TVA-BFN-TS-431

**BROWNS FERRY NUCLEAR PLANT (BFN) - UNIT 1 - TECHNICAL
SPECIFICATIONS (TS) CHANGE TS-431, SUPPLEMENT 1 - EXTENDED
POWER UPDATE (EPU) (TAC NO. MC3812)**

**BROWNS FERRY NUCLEAR PLANT (BFN) - UNIT 1 - TECHNICAL
SPECIFICATIONS (TS) CHANGE TS-431, SUPPLEMENT 1 -
EXTENDED POWER UPRATE (EPU)**

TVA EVALUATION OF THE PROPOSED CHANGE

Figure 3.4.1-1
THERMAL POWER VERSUS CORE FLOW STABILITY REGIONS

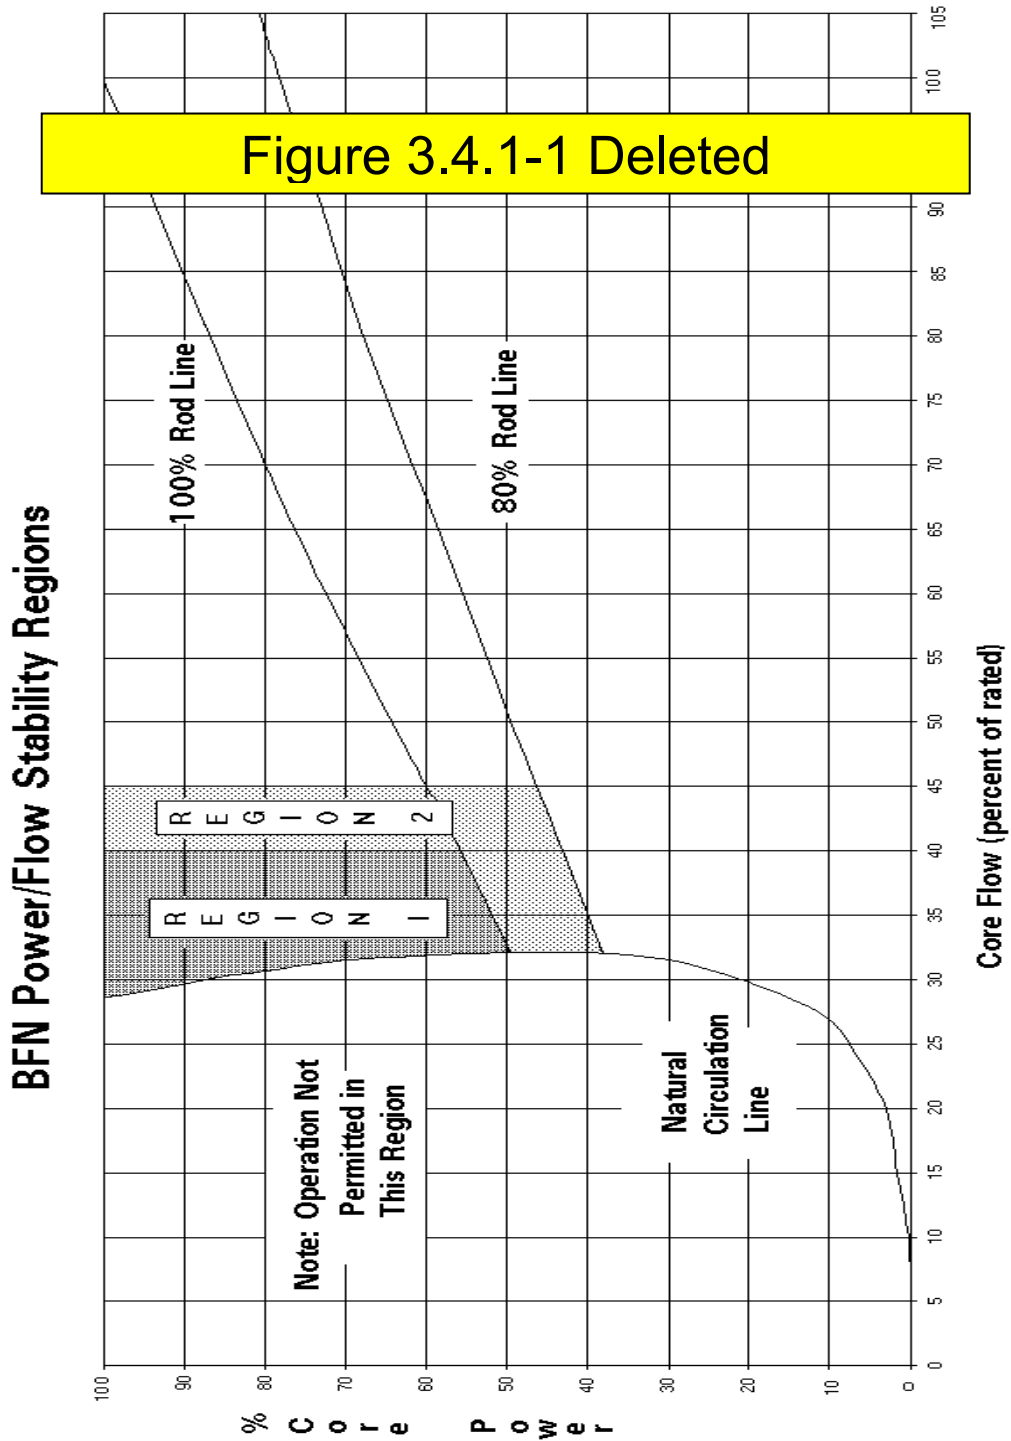
FIGURE 3.4.1-1 Deleted
